Re: Case No. 20-417-EL-BGN -In the Matter of the Application of Grover Hill Wind, LLC for a Certificate of Environmental Compatibility and Public Need to Construct a Wind-Powered Electric Generation Facility in Paulding County, Ohio.

Response to Seventh Data Request from Staff of the Ohio Power Siting Board

**GROVER HILL WIND, LLC 'S
RESPONSE TO THE SEVENTH DATA REQUEST
FROM THE STAFF OF THE OHIO POWER SITING BOARD**

FIGURE 1 MEASUREMENT LOCATIONS

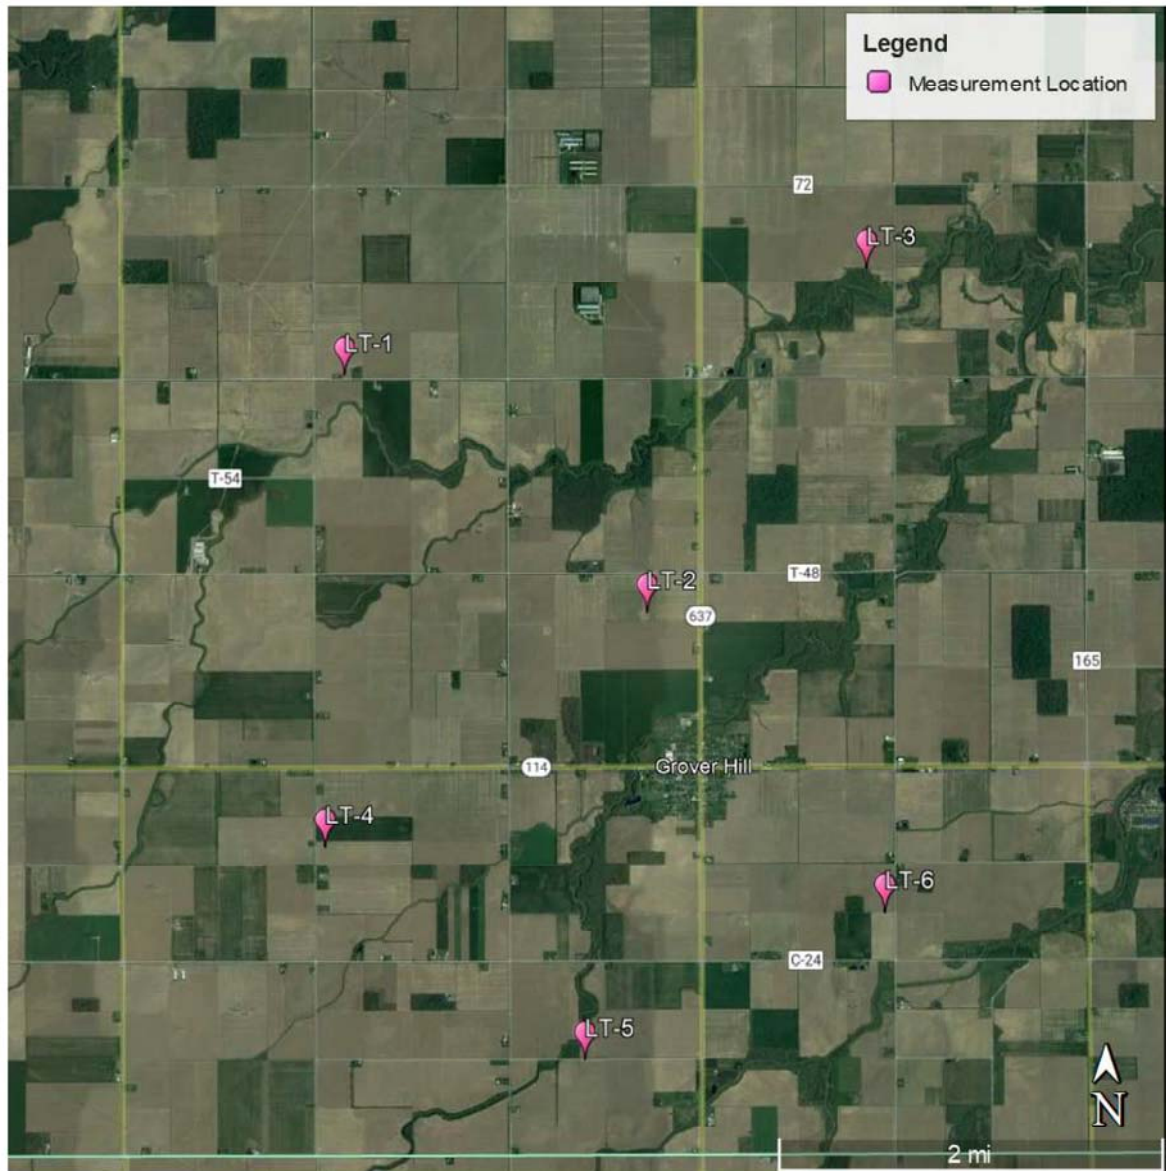
- 3. Previously, Question 18 asked why were each of ambient locations chosen. Please explain the rationale for choosing location 1, please explain the rationale for choosing location 2, please explain the rationale for choosing location 3, please explain the**

rationale for choosing location 4, please explain the rationale for choosing location 5, and please explain the rationale for choosing location 6.

4. For each of the ambient locations please provide photos of the placement of the meter in their measurement location at the time of the measurement.
5. How far from the road were each of the meters placed?

Measurements were taken at six locations throughout the project area (Figure 1). These locations were selected to cover the project area, conform with ANSI/ASA S12.9 siting requirements, and capture the variety of existing ambient conditions within the project area. Site selection and photographs are included in the next section.

Six sites were selected for noise monitoring. They were selected to best cover the whole project area, represent the varying acoustic conditions, and accommodate land access restrictions. Each site is listed with rationale for its location, a photograph, and aerial map detail.
